**PLANNING COMMISSION
STAFF REPORT**

AGENDA ITEM: Planning File No. MODSP-26-0001: A modification to MAJ-24-0005 and CU-24-0001 to make modifications to the proposed building materials, number of decks, number of windows, along with other minor modifications described in the applicant’s narrative.

LOCATION: 200 N 7th Ave / Lot E-2 River Pines Sub Resub Outlot E Replat A River Pines

3. Fascia Wood Siding

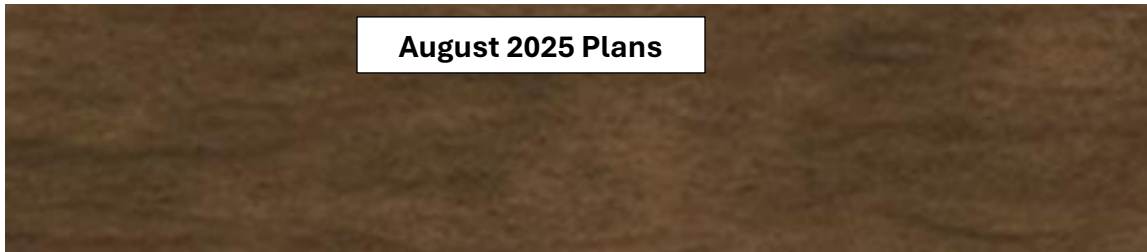
The Application maintains the previously approved vertical siding material but modifies the pattern of the vertical elements. The original design included a randomized pattern of 2-inch, 4-inch, and 8-inch-wide vertical members as shown in the picture below. The Applicant now proposes to standardize the siding to 8-inch-wide vertical members. This modification is intended to create a more consistent and uniform appearance across the façade while maintaining the approved material and overall design intent. Staff finds that this change does not alter the fundamental character of the approved design.

The original application specified fascia siding as a standard cedar product. To maintain consistency with the proposed LP SmartSide horizontal siding, the Applicant proposes using LP SmartSide fascia siding, an engineered wood product designed to replicate the appearance of cedar. The proposed fascia will be the same width and match the color of the originally approved material. The image provided from the August 2025 application of the fascia wood siding in the picture below represents the appearance and finish of the fascia siding as well. Staff notes that this product is commonly used throughout the Town and finds that the proposed change maintains the overall design intent and visual consistency of the façade.

SAFFRON CEDAR

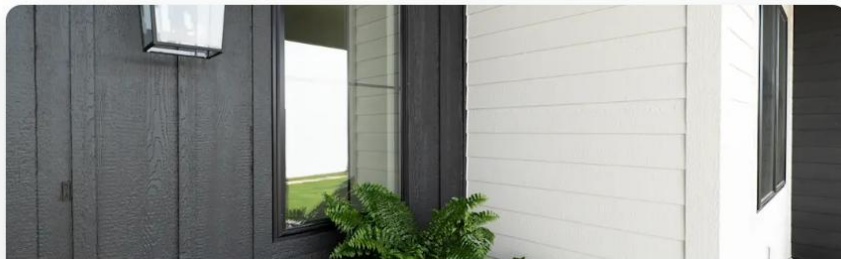
Staff obtained this Information from the website regarding LP SmartSide fascia, which the Applicant verified as accurate.
